SECTION 00 91 01

**ADDENDUM NO. 1**

This document includes requirements that clarify or supersede portions of the Request for Proposal. This Addendum is a Contract Document.

**BUILDINGS 5 & 6 RENOVATIONS**  
 San Mateo County Community College District

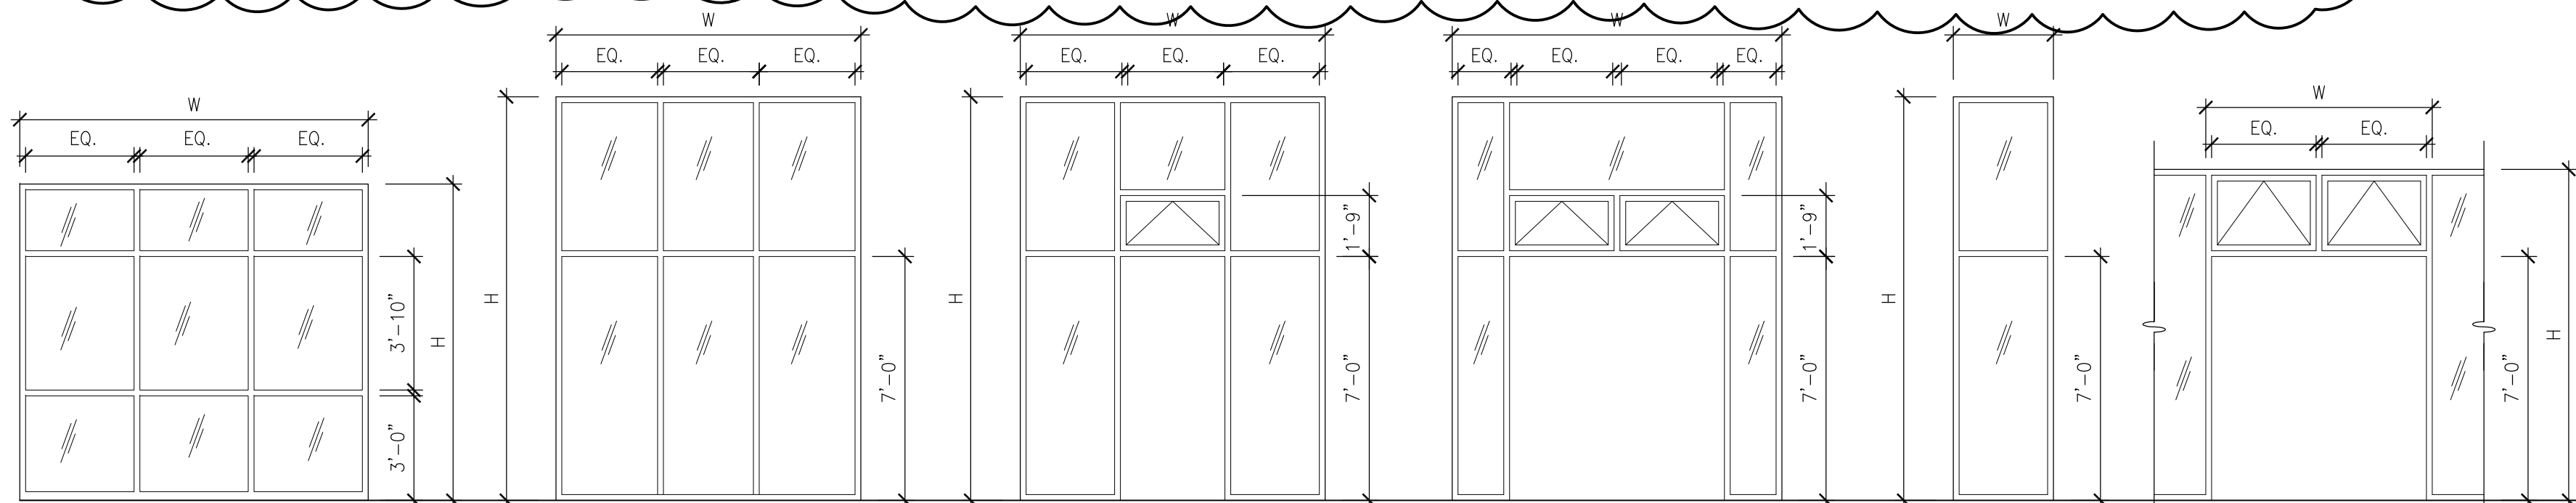
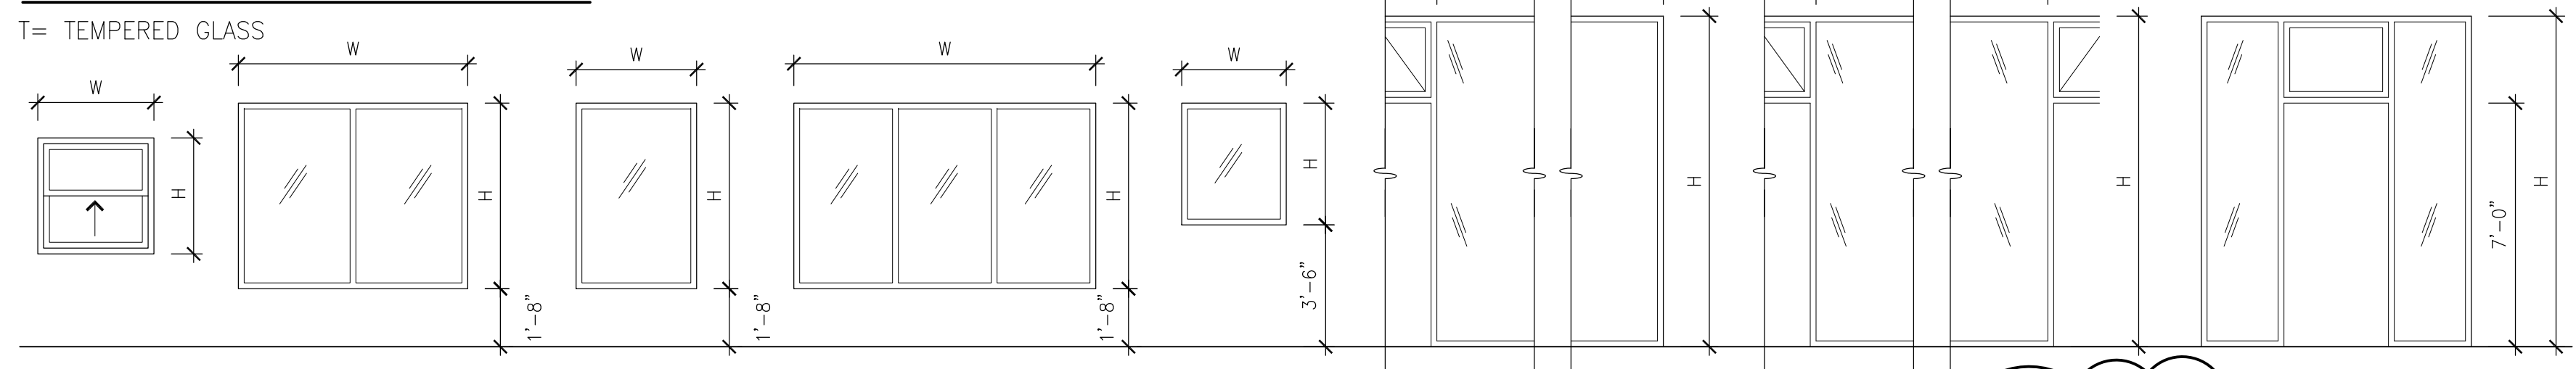
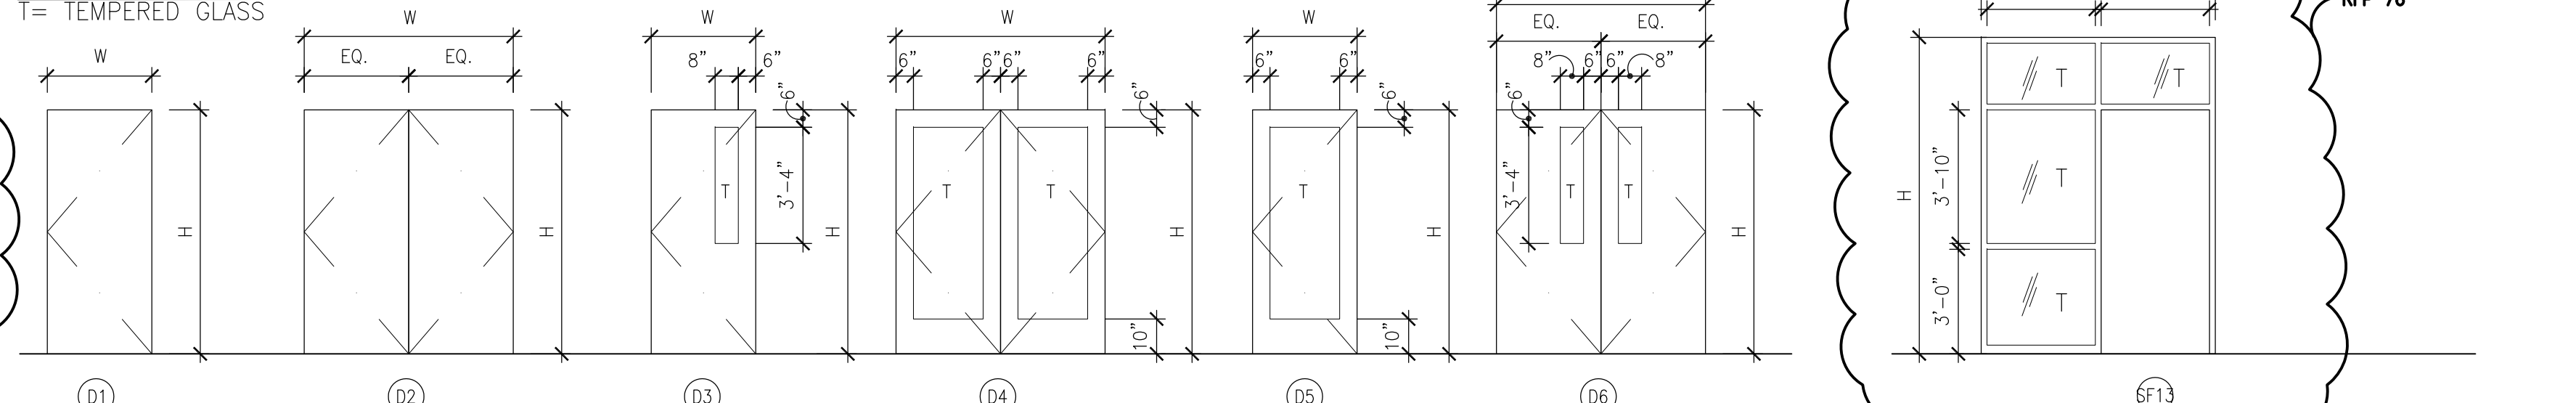
- 3. Add Sheet Note 136 for AV Patch Panel
    - 4. Add location for AV Patch Panel on Interior Elevation 6A
    - 5. Delete Sheet Note 117.
- 6. Drawing A9.1R – Finish, Window Schedules.

- A. Modified drawing as shown on attached revised Drawing A9.1R:
    - 1. Revised Finish Legend to include the following colors of Altro Dolce resilient flooring:

FLOOR	
RESILIENT FLOORING 5:	COLOR: ALTRO DOLCE # AD514.
RESILIENT FLOORING 6:	COLOR: ALTRO DOLCE # AD504.
RESILIENT FLOORING 7:	COLOR: ALTRO DOLCE # AD512.
RESILIENT FLOORING 8:	COLOR: ALTRO DOLCE # AD515.

**THIRD FLOOR FINISH AND SIGNAGE PLAN**

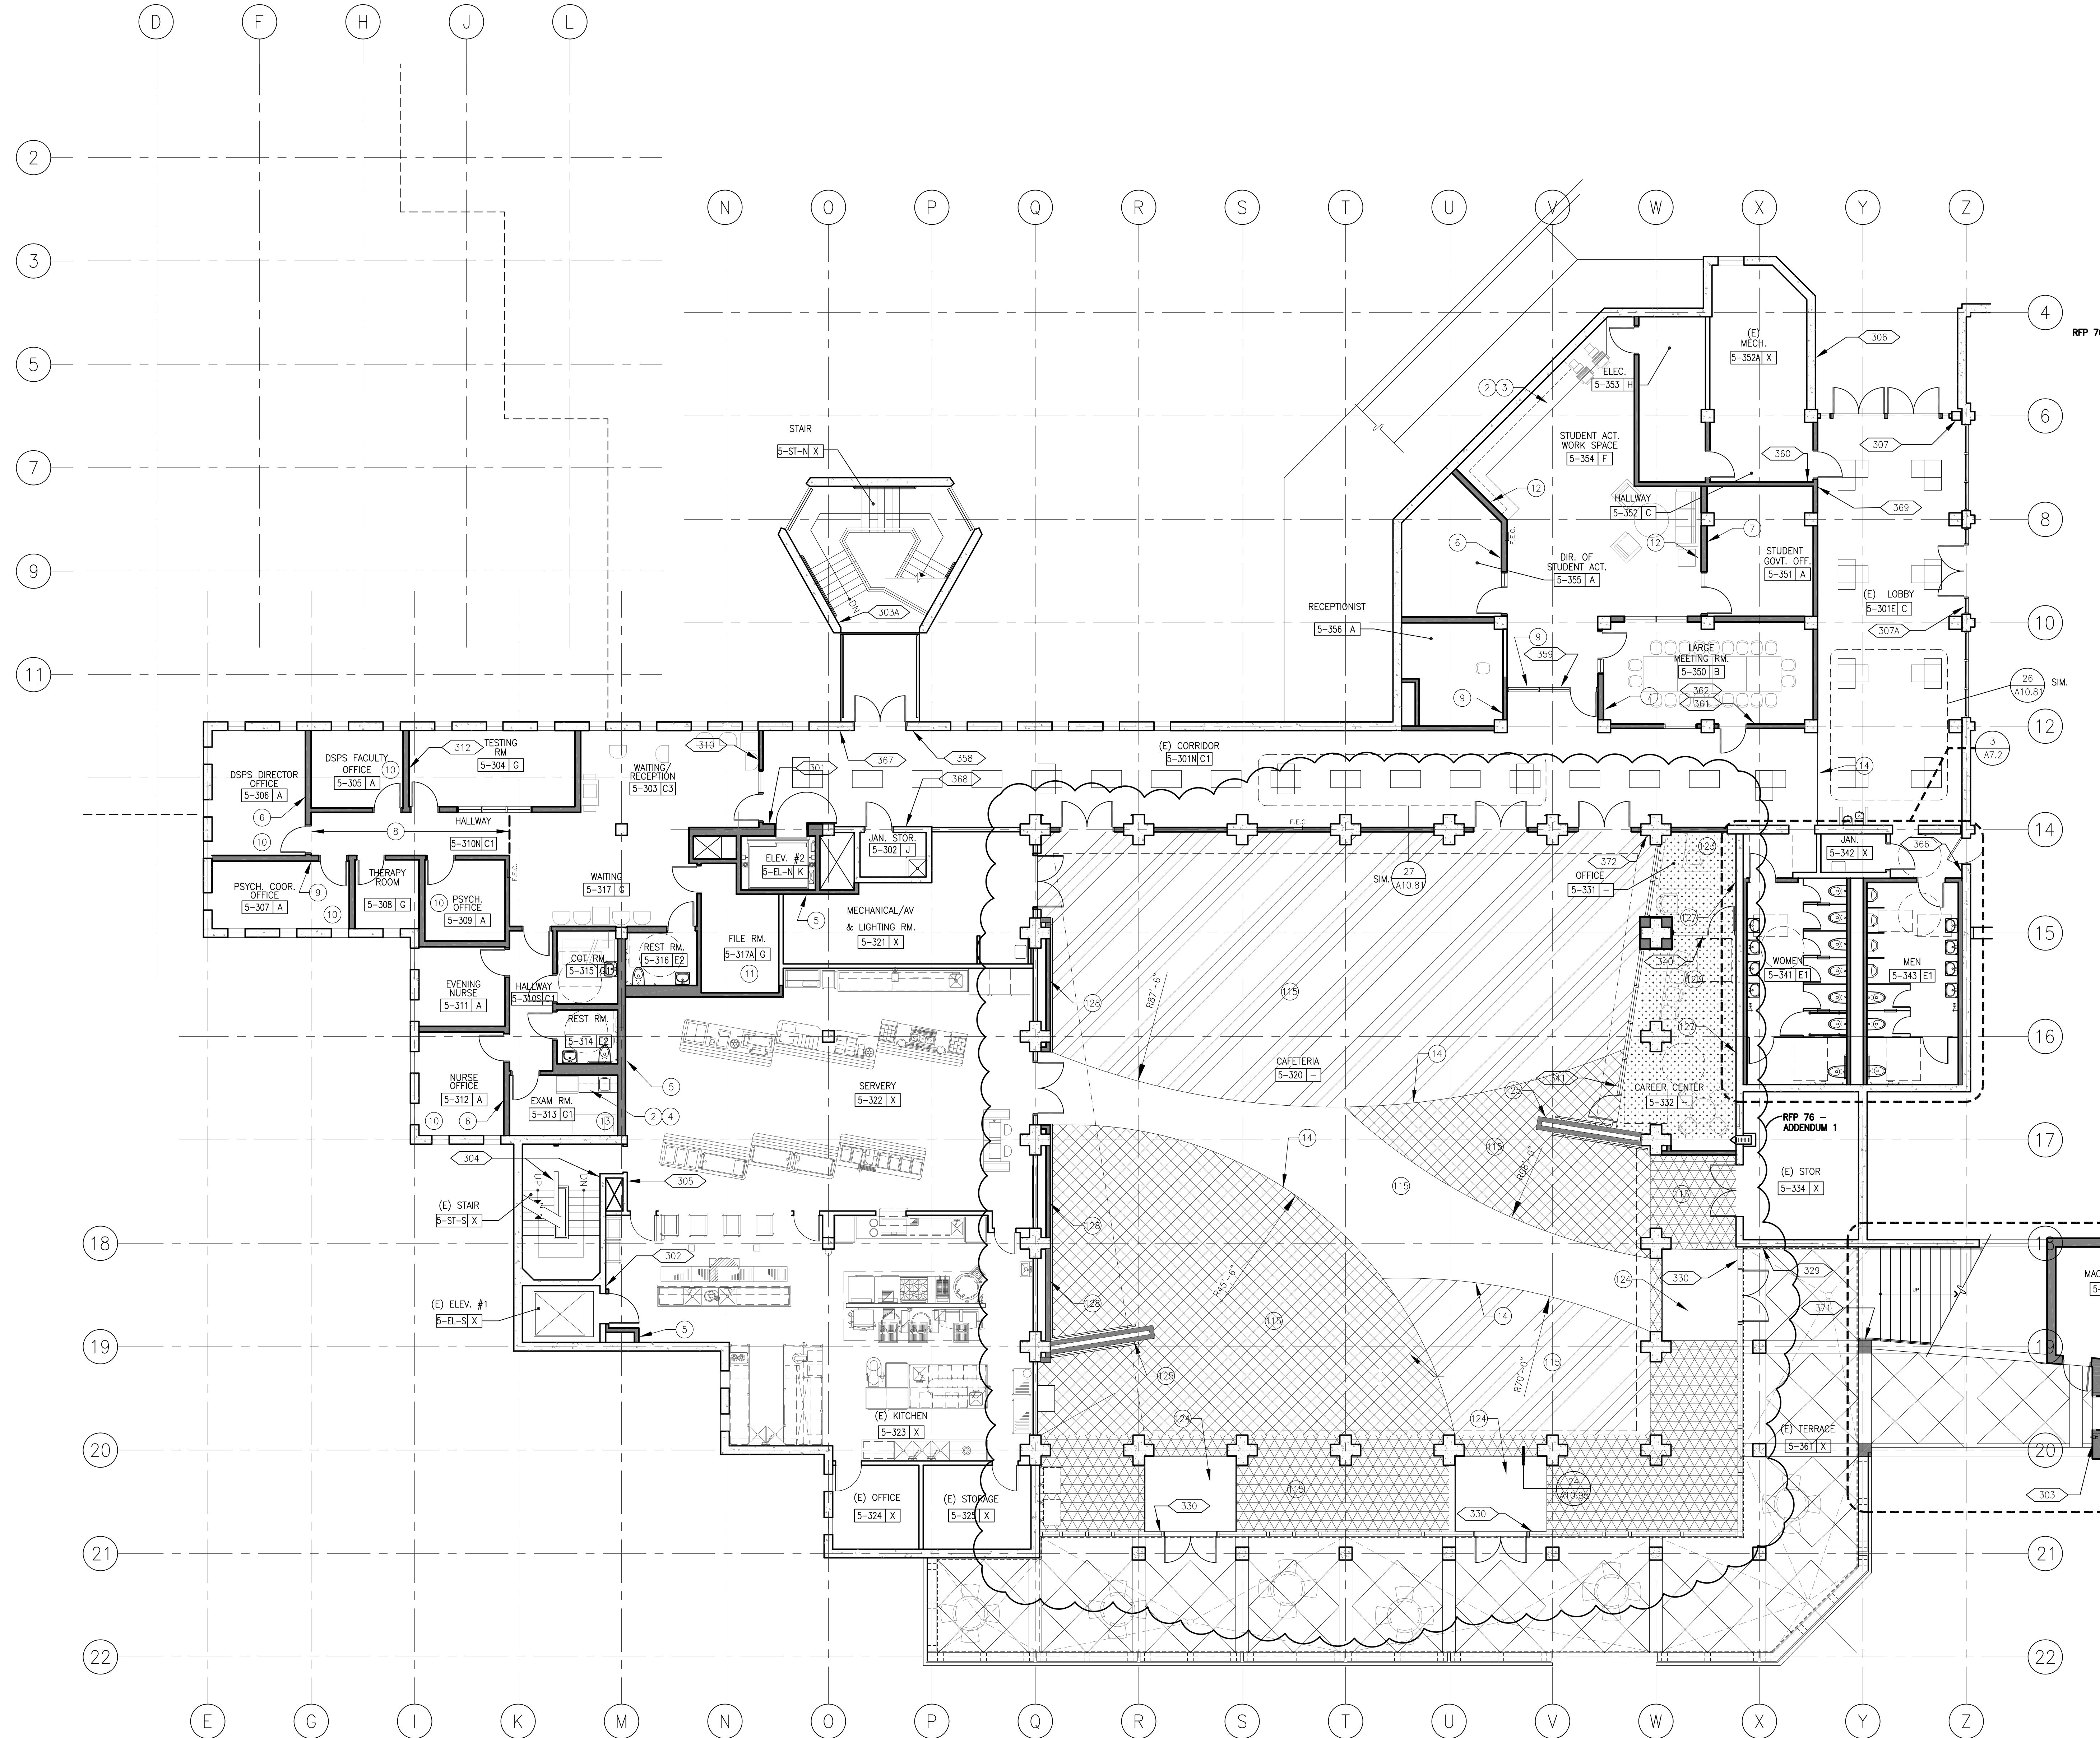
7. Drawing A9.43R – Third Floor Finish and Signage Plan.
  - A. Modified drawing as shown on attached revised Drawing A9.43R:
    1. Revised Finish Legend and Third Floor Finish and Signage Plan.

2. Revised Sheet Note 115.
8. Drawing A9.44R – Third Floor Finish and Signage Plan – Add Alternates.
  - A. Modified drawing as shown on attached revised Drawing A9.44R:

Date: 04/22/11  
Scale: AS NOTED  
Project Number: 07013  
Drawing Number: A9.44R

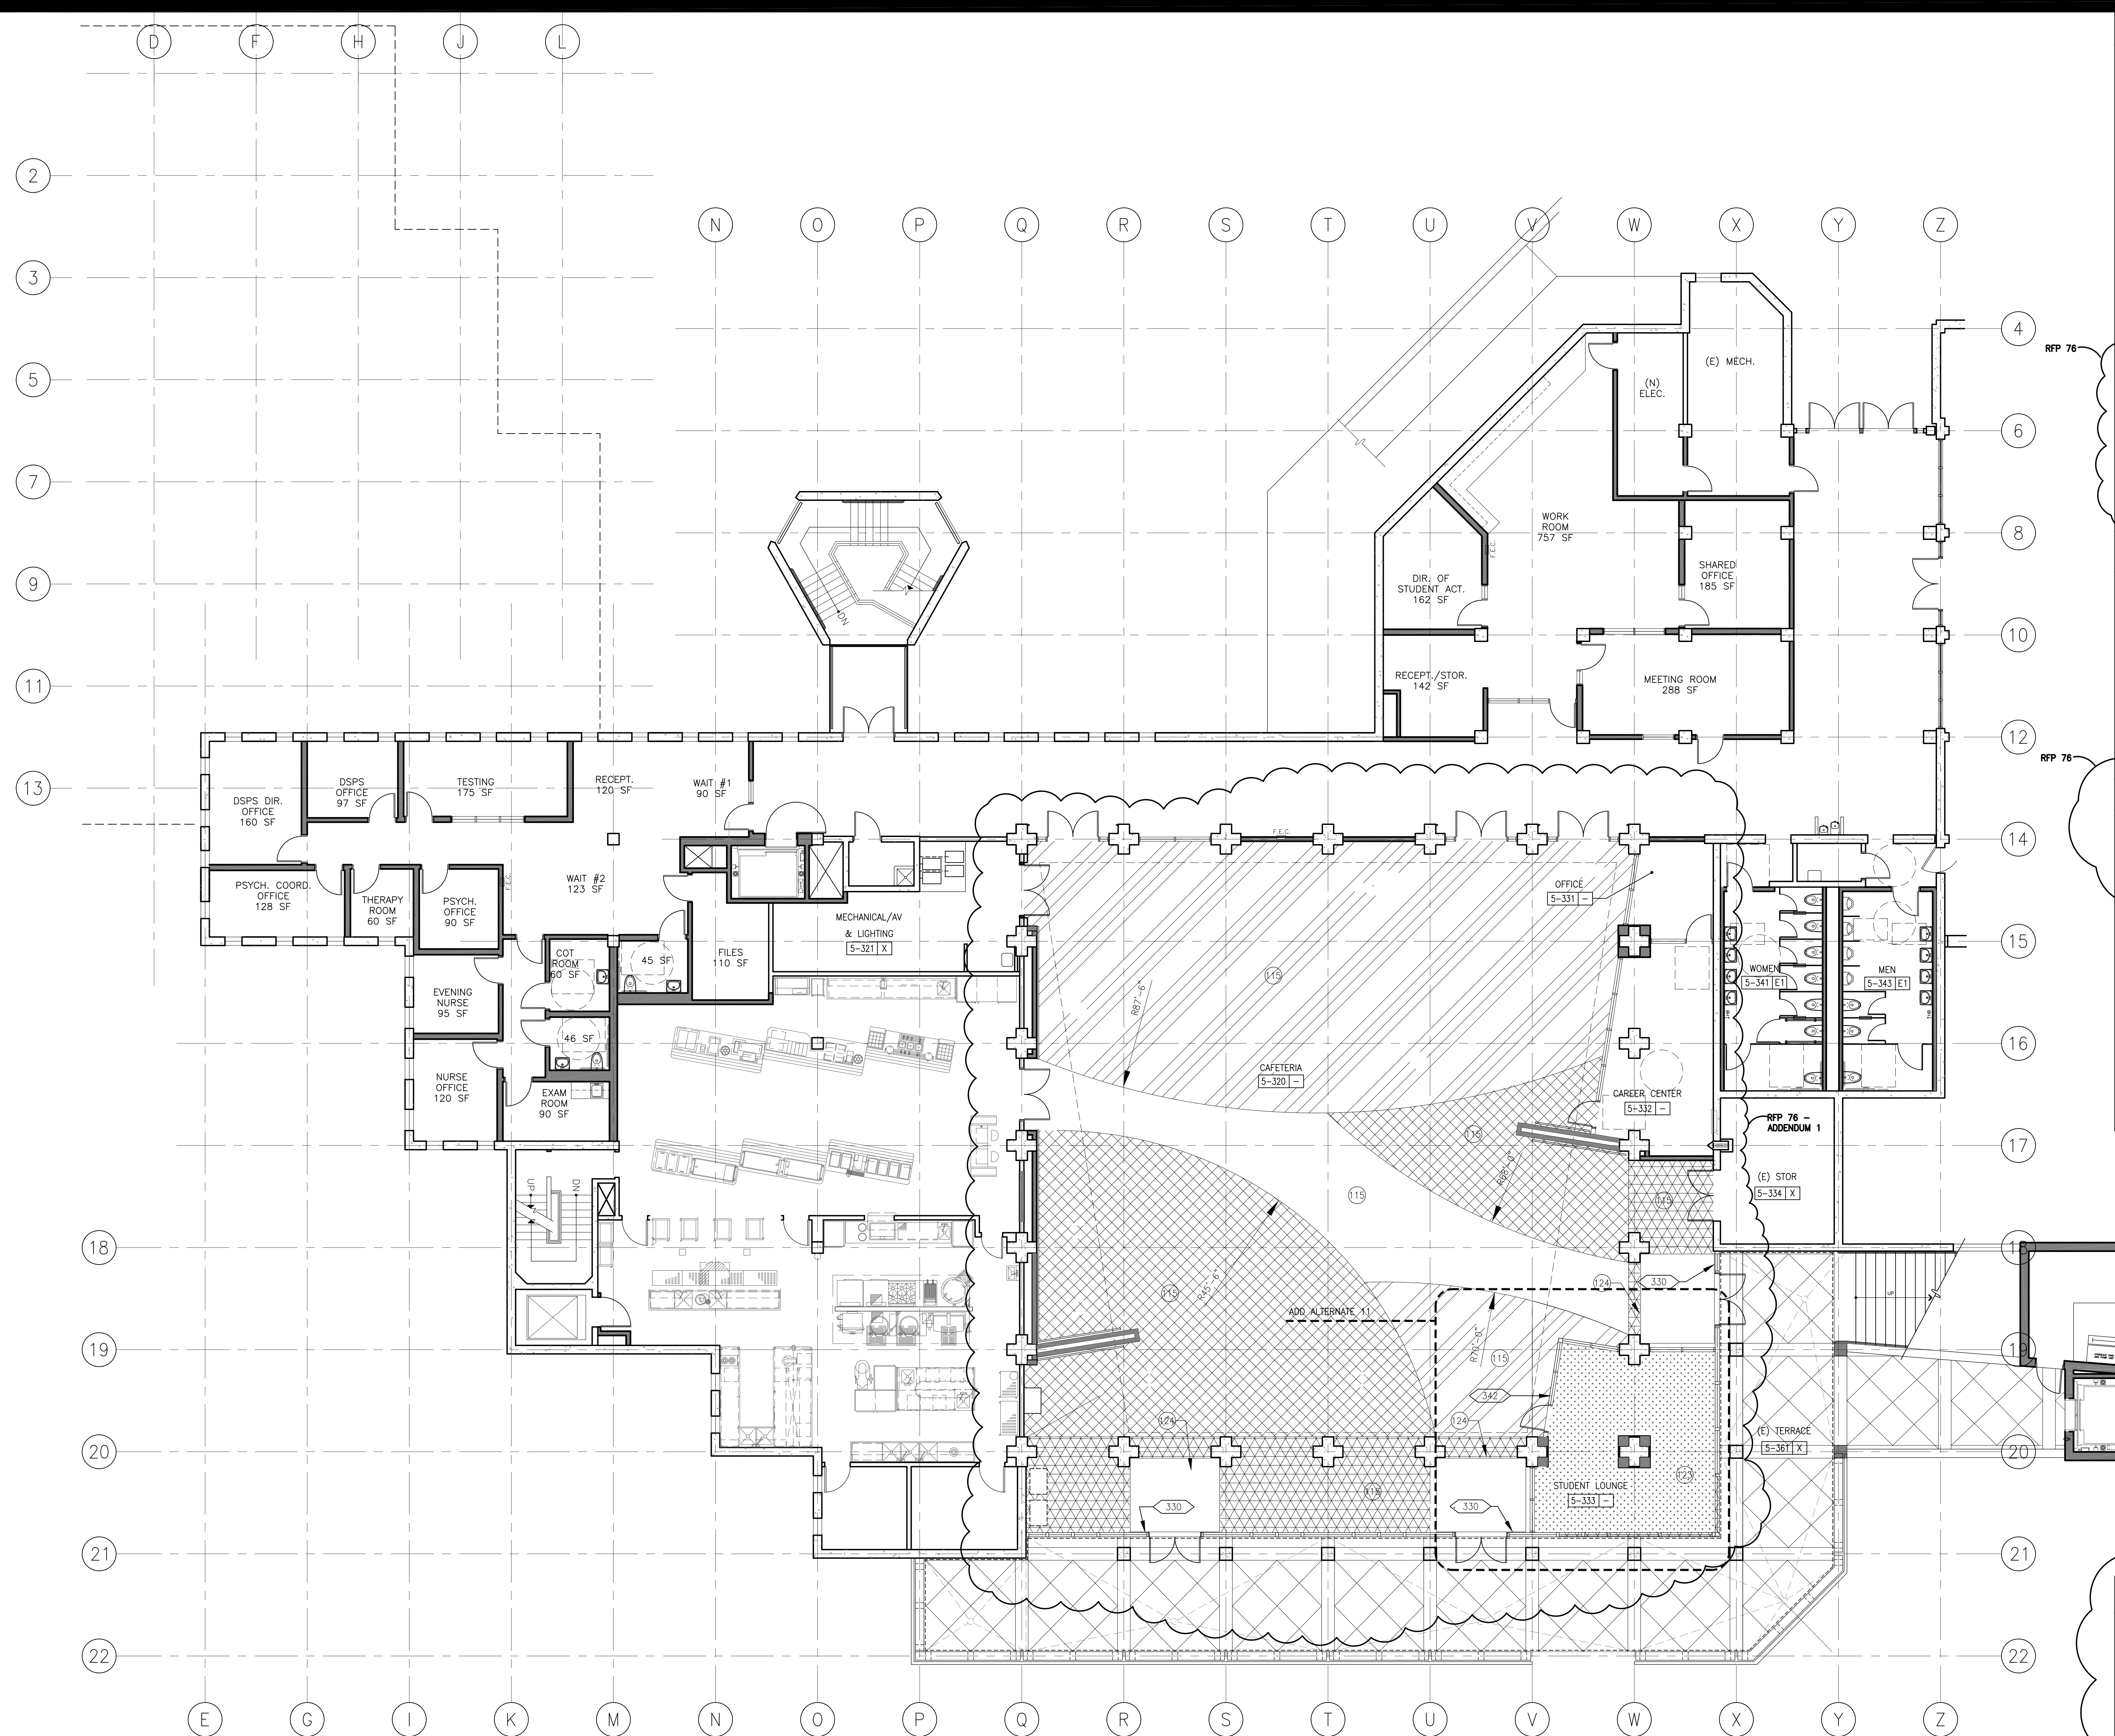
1. Revised Finish Legend and Third Floor Finish and Signage Plan.
    2. Revised Sheet Note 115.
9. Drawing A10.93R – Wall Types and Casework Details.
